## Technical Note

Project:	Whitby Park and Ride Site Assessment	Job No:	60041470
Subject:	Assessment of North Yorkshire County Council Revised Planning Application		
Prepared by:	Clive Staples	Date:	29 <sup>th</sup> September 2008
Checked by:	Simon Pratt	Date:	29 <sup>th</sup> September 2008
Approved by:	Simon Pratt	Date:	29 <sup>th</sup> September 2008

**Appendix A**  
**Alternative Park and Ride Site**  
**Redesigned Access Drawing**

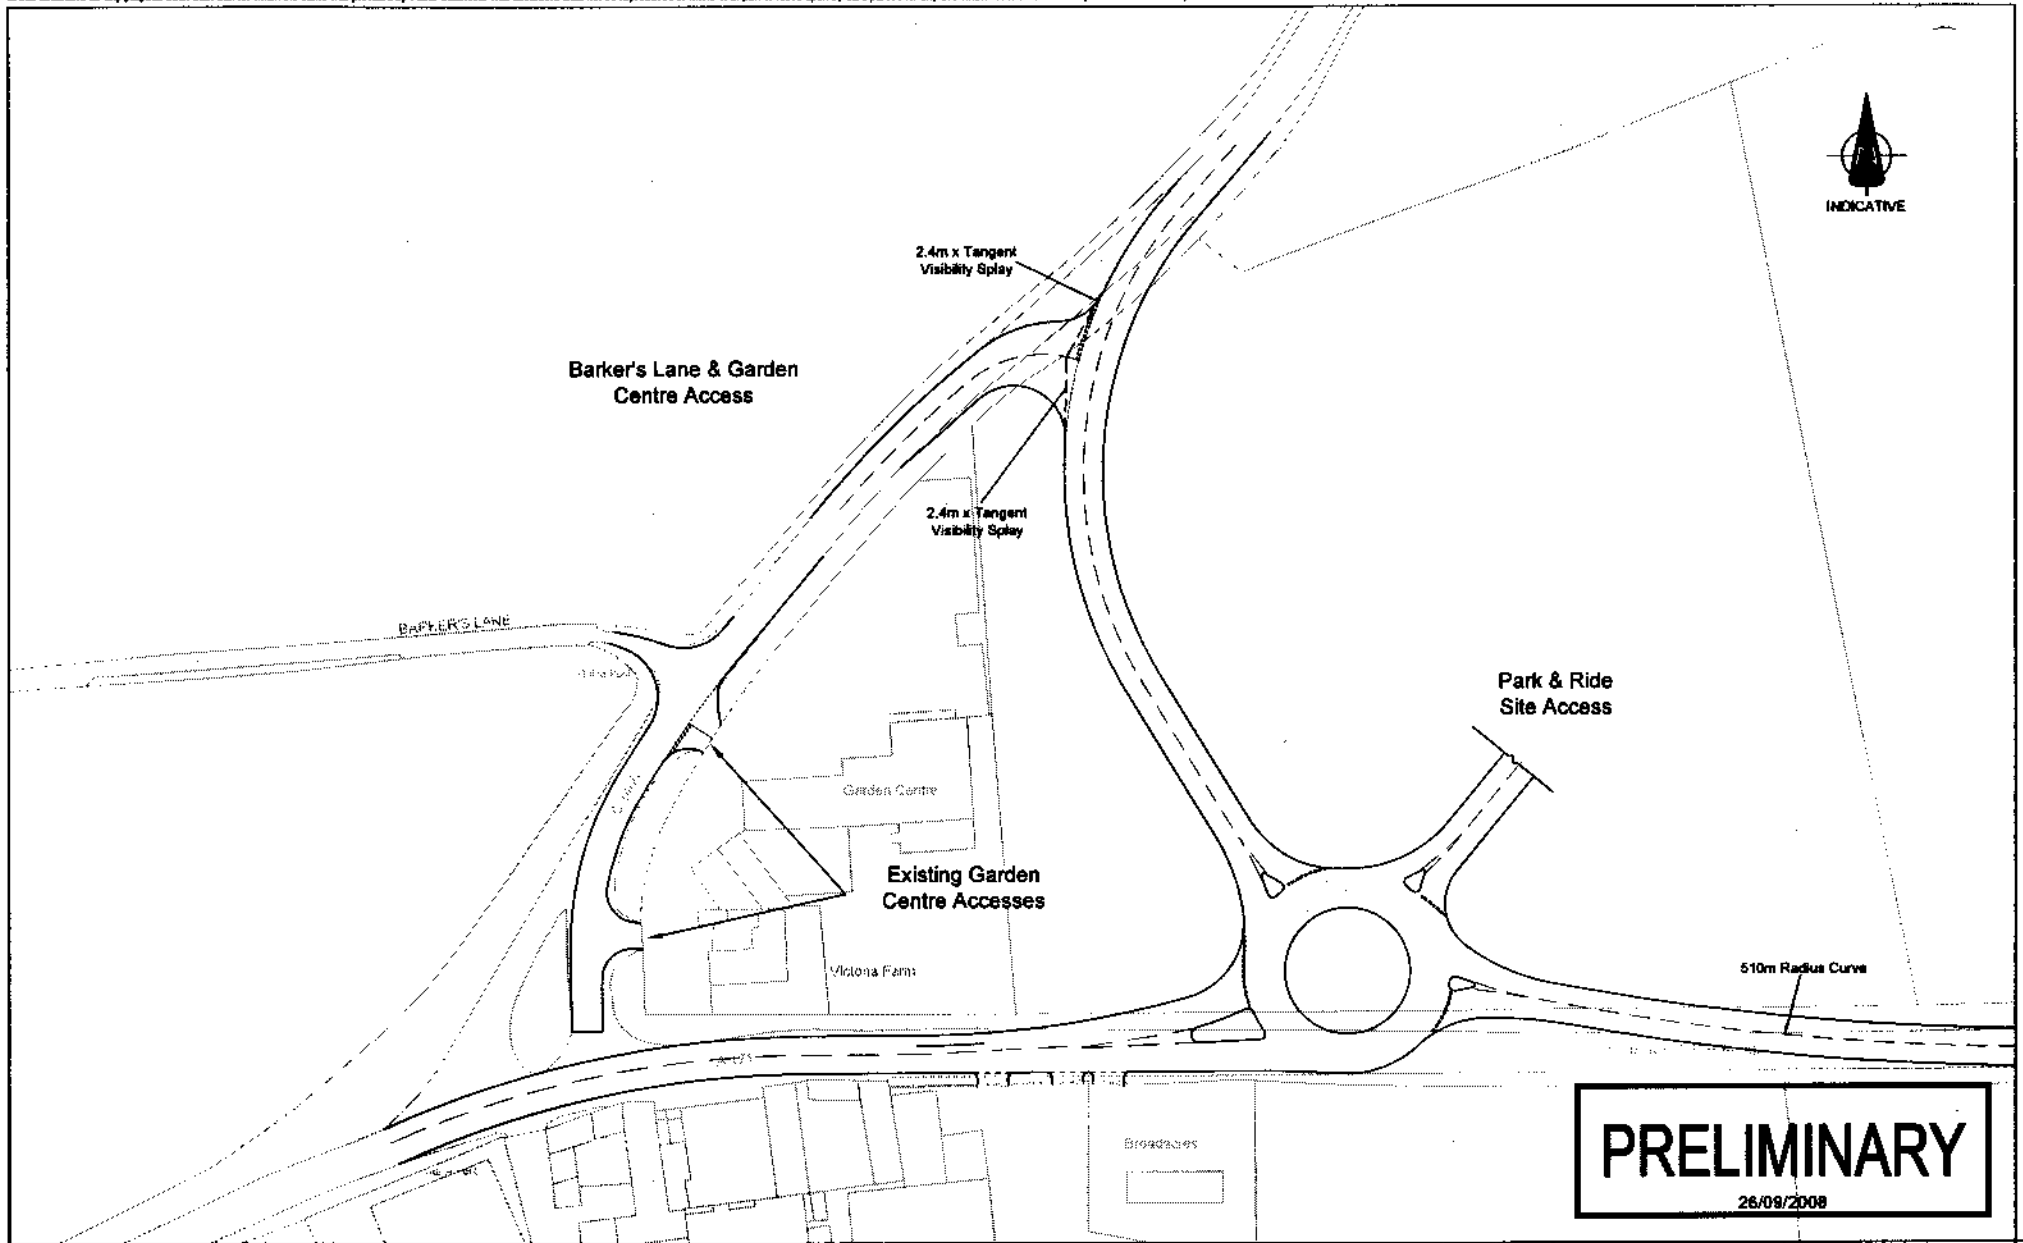
NYCC have made comments regarding the Option 3 design falling outside design standards, particularly the requirement for reverse curvature on the A171 westbound approach. To address this issue, and with the advent of traffic flow information, to adapt the design of the roundabout to cater for the demand flows, a further design for a possible roundabout at this location has been undertaken. This is shown at **Appendix A** to this note, in Drawing No. 60041470-P-003 Rev A. The revisions to the layout include for a 510m radius curve on the A171 westbound approach to the junction (a suitable standard for the design speed of the A171), changes to the A171 westbound entry to the roundabout, slight realignment of the park and ride access at the roundabout, and realignment and tie-in to the existing B1460 carriageway.

These results indicate that the junction is within capacity on all arms and the queues and delays are significantly reduced from that proposed by NYCC. In fact, the assessment results are better than the assessment conducted by NYCC for the application site.

When considering the routing of the bus service as described in the previous section of this note, the operation of the redesigned Option 3 roundabout as detailed above can be further improved if the routing of the bus service is considered in an anti-clockwise direction. This would allow the bus a left turn from the roundabout to the A171, and a left turn into the site from the B1460. When this operational change is modelled in ARCADY, the resulting improvements in the junction performance can be seen in Table 4 below. This shows further improvements over the assessment of the application site roundabout.
